Access Compliance Report

Public Rights-of-Way

(Curb Ramps)

Intersection ID: 10017072	Main Street: UNIVERSITY_CITY_BV	Cross Street: N/A	Location: E
ADA ID: F78B89E7A9BF	Ramp Type: BlendTrans1	Initial Pass/Fail: Fail	Overall Compliance: No
		Severity Score: 12.5

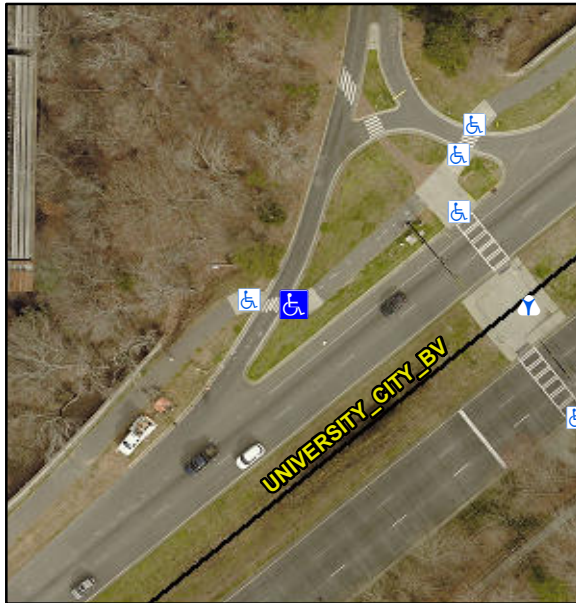
Not Found, R304.5.3

Compliance	Description	Data	Compliance	Description	Data
N/A	Ramp Length (in)	143.0	Yes	BlendTrans Slope (%)	3.5
Yes	Ramp Width (in)	123.0	No	BlendTrans XSlope (%)	5.4
N/A	Flare Type LT	N/A	N/A	Flare Type RT	N/A
N/A	Flare Slope LT (%)	N/A	N/A	Flare Slope RT (%)	N/A
N/A	Flare Traversable LT?	N/A	N/A	Flare Traversable RT?	N/A
N/A	Landing Length (in)	N/A	N/A	DWS Provided?	N/A
N/A	Landing Width (in)	N/A	N/A	DWS Contrast?	N/A
N/A	Landing Slope (%)	N/A	N/A	DWS Length (in)	N/A
N/A	Landing X Slope (%)	N/A	N/A	DWS Full Width?	N/A
N/A	Landing Curb? (Y/N)	N/A	N/A	DWS Offset (in)	N/A
N/A	Shared Landing?	N/A			
N/A	Gutter Ponding?	N/A	N/A	Gutter Slope (%)	N/A
N/A	Gutter Lip Ht (in)	N/A	N/A	Gutter X Slope (%)	N/A
N/A	Painted X Walk1?	Yes	N/A	Painted X Walk2?	N/A
	X Walk 1 Direction	To W		X Walk 2 Direction	N/A
	X Walk 1 Width (in)	117.0		X Walk 2 Width (in)	N/A
	X Walk 1 Slope (%)	5.9		X Walk 2 Slope (%)	N/A
	X Walk 1 X Slope (%)	3.0		X Walk 2 X Slope (%)	N/A

N/A	Ramp inside XWalk1?	Yes	N/A	Ramp inside XWalk2?	N/A
	Road Slope (%)	3.0		Clear Space?	N/A
	Road X Slope (%)	5.9	N/A	Clear Space to XWalk (in)	N/A
N/A	Any Obstructions?	N/A	N/A	Storm Grate/Utility Hazard?	N/A
	Obstruction Type			Storm Grate/Utility Type	
		N/A			N/A
			Yes	Surface Condition? (G/P)	Good
			No	Curb Slope (%)	20.7

Remove & Replace Curb Ramp With Two New Directional Ramps or Equivalent.
